BYLONG COAL PROJECT

SUPPLEMENTARY INFORMATION

July 2018

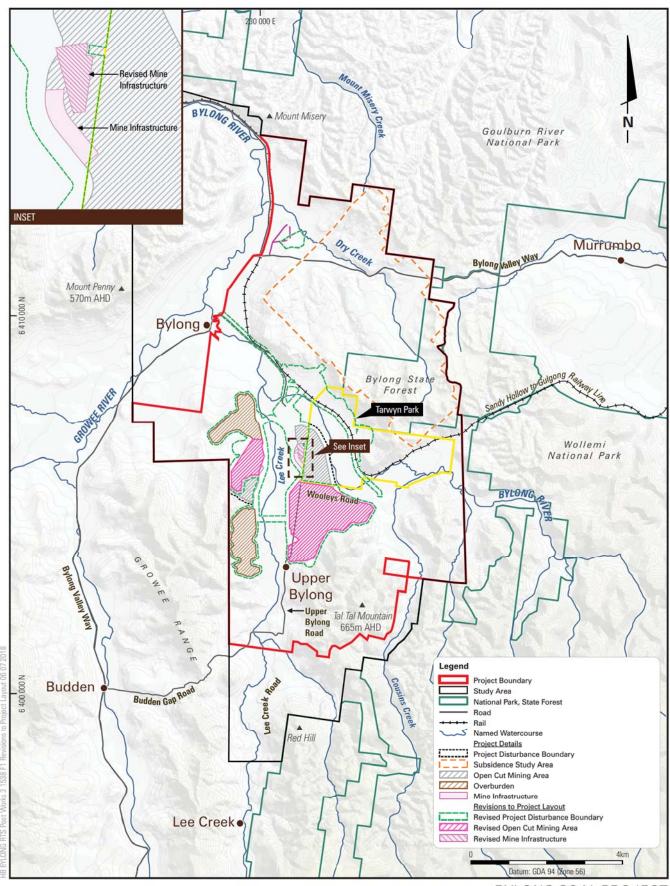
Figure 1 overlays the open cut mine plan revisions proposed by DPE on the EIS mine plan for the Project. **Figure 2** illustrates the proposed Conceptual Project Layout as per DPE's request (the Revised Mine Plan). Key features of the Revised Mine Plan include:

Revised Conceptual Project Layout

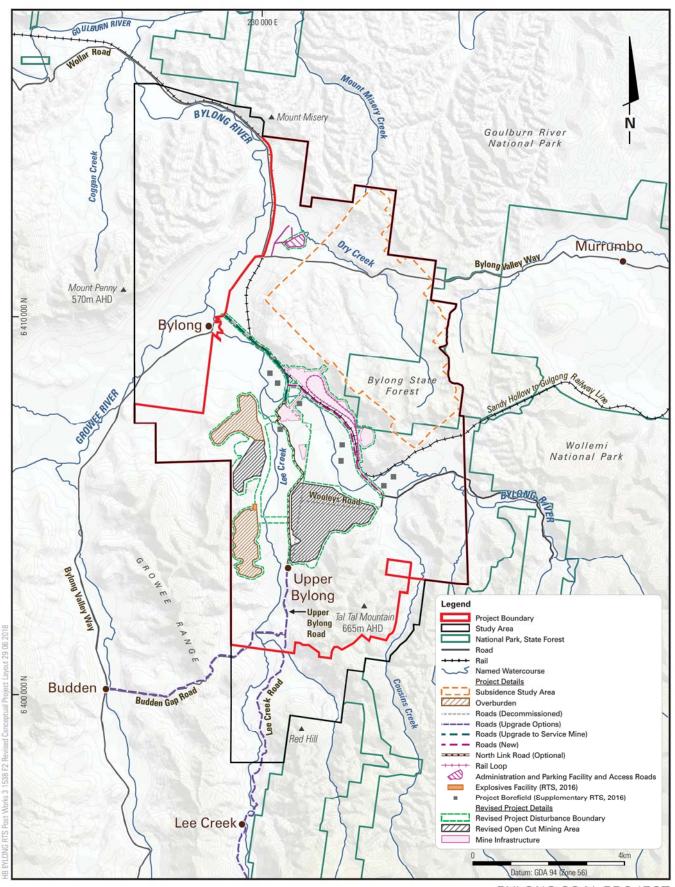
The Project with the Revised Mine Plan will require approximately 1,047 hectares (ha) of surface disturbance (compared to 1,160 ha assessed within the EIS as shown on **Figure 1**) which will generally be undertaken within the Revised Project Disturbance Boundary as illustrated in **Figure 2**.

The Revised Project Disturbance Boundary comprises the areas required to accommodate the key surface components of the Revised Mine Plan for the Project with provision for minor adjustments during final design and development. The disturbance areas will be progressively rehabilitated as areas become practically available and where feasible will be reinstated to the pre-mining land use. The Subsidence Study Area (as illustrated in **Figure 2**) will not change from that assessed within the EIS.

Revised Conceptual Final Landform

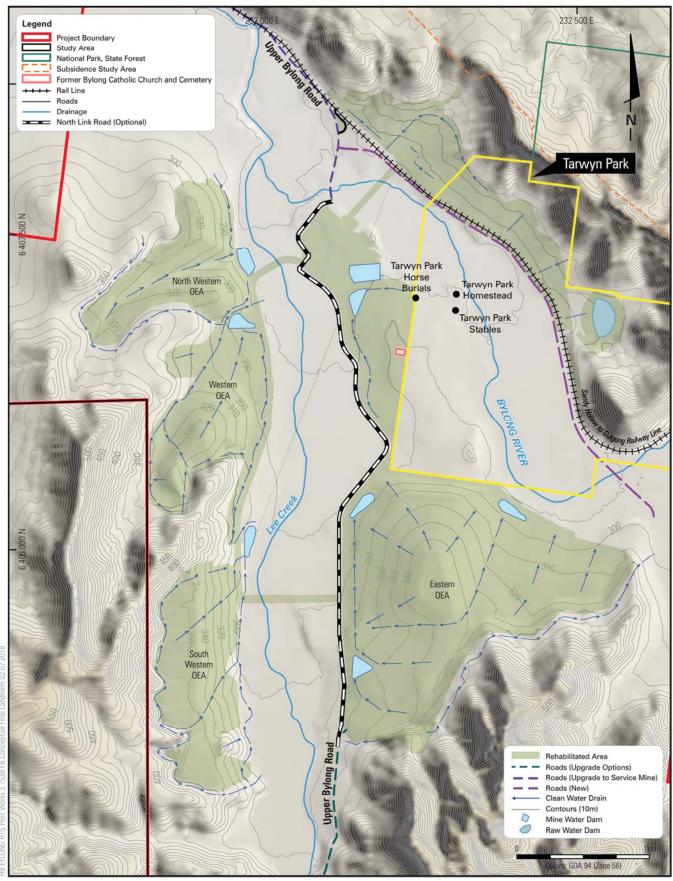
KEPCO's mine planning team has developed a revised Conceptual Final Landform based on the mine planning principles which were developed throughout the Project's extensive mine planning process. In this regard, the Conceptual Final Landform as illustrated within **Figure 8**, accommodates similar attributes to the EIS mine plan, albeit with reduced footprints and improved landform design elements.

The North Western OEA and South Western OEA have adopted some additional design principles from the EIS in order to address concerns in relation to the proposed landform which have recently been raised by the Heritage Council. The North Western OEA will continue to occupy the same footprint as that proposed within the EIS. However, the revised landform has incorporated the existing valley which extends from the northern portion of the Growee Ranges down to the Lee Creek floodplain on the south-eastern side of the Telstra Hill. The inclusion of this landscape feature aims to minimise the visual effects of the North Western OEA to views from Tarwyn Park and to blend the landform in with the natural topography to the maximum extent possible. Similarly, the South Western OEA has been redesigned with a reduced height to minimise the area of steeper sloping land on the western side of this landform.

The Eastern OEA generally represents a similar landform to that presented within the EIS (albeit with reduced footprint to remain off Tarwyn Park). The conceptual design for the Western OEA will also be developed generally consistent with the EIS mine plan, with exception of the contracted footprint within the south eastern extent of the Western Open Cut.

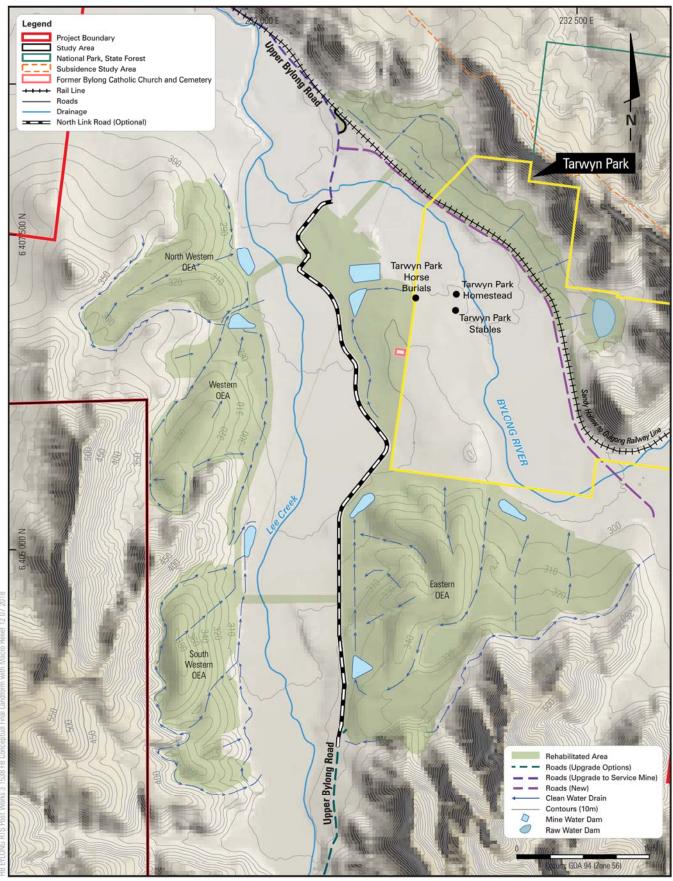
In light of the concerns raised within the PAC Review Report and subsequent Heritage Council correspondence in relation to the uniform nature of the Conceptual Final Landform design, KEPCO's mine planning team has completed some detailed landform design work to develop a revised Conceptual Final Landform design which incorporates macro relief (revised Conceptual Final Landform with Macro Relief) (see **Figure 9**). The mine planning information developed for the revised Conceptual Final Landform has been utilised as the basis of the macro relief design. It is noted that a similar detailed mine planning process will be undertaken as part of the RMP/MOP process to address the Project's rehabilitation objectives should the EIS Mine Plan be approved.

KEPCO's mine planning team conducted a detailed investigation of the surrounding natural topography and has incorporated the shape and character of natural topographic features into the final landform design for the Revised Mine Plan. The key natural topographic features identified by the mine planning team for use within the final landform design included:

- Branching ridgelines;
- Ridgelines between 50 metres (m) and 130 m wide;
- Ridgelines having gentle grades, then steeper down to the valley floor; and
- Ridge side slopes generally >20 degrees.

The revised Conceptual Final Landform with Macro Relief as illustrated in **Figure 9** incorporates the following design features:

Impacts to Historic Heritage Sites

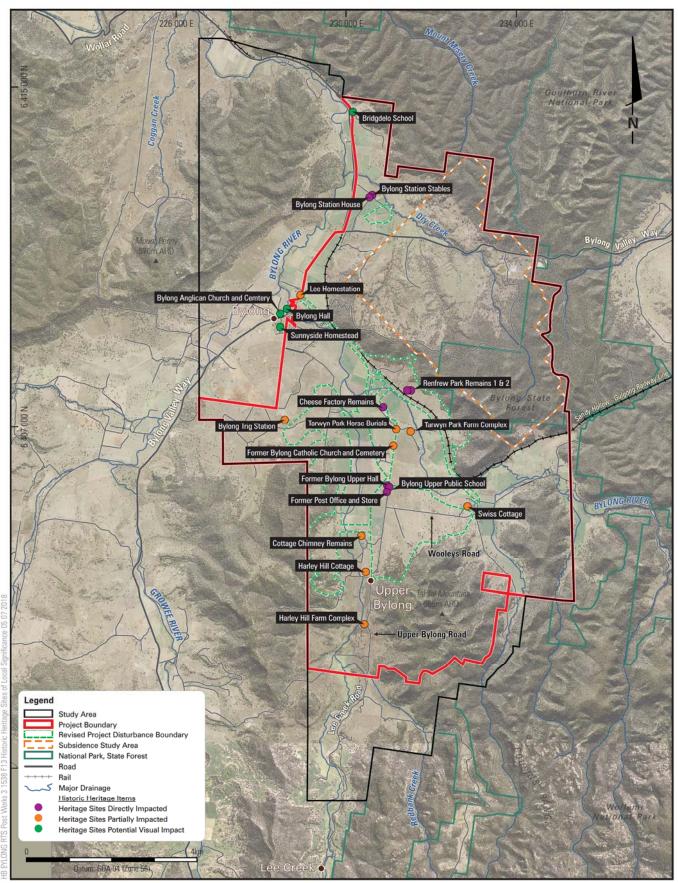
Table 7 illustrates the heritage items which will experience reduced impacts in comparison with the previous assessments. **Figure 13** illustrates the revised impact analysis of historic heritage sites within the study area due to the Revised Mine Plan.
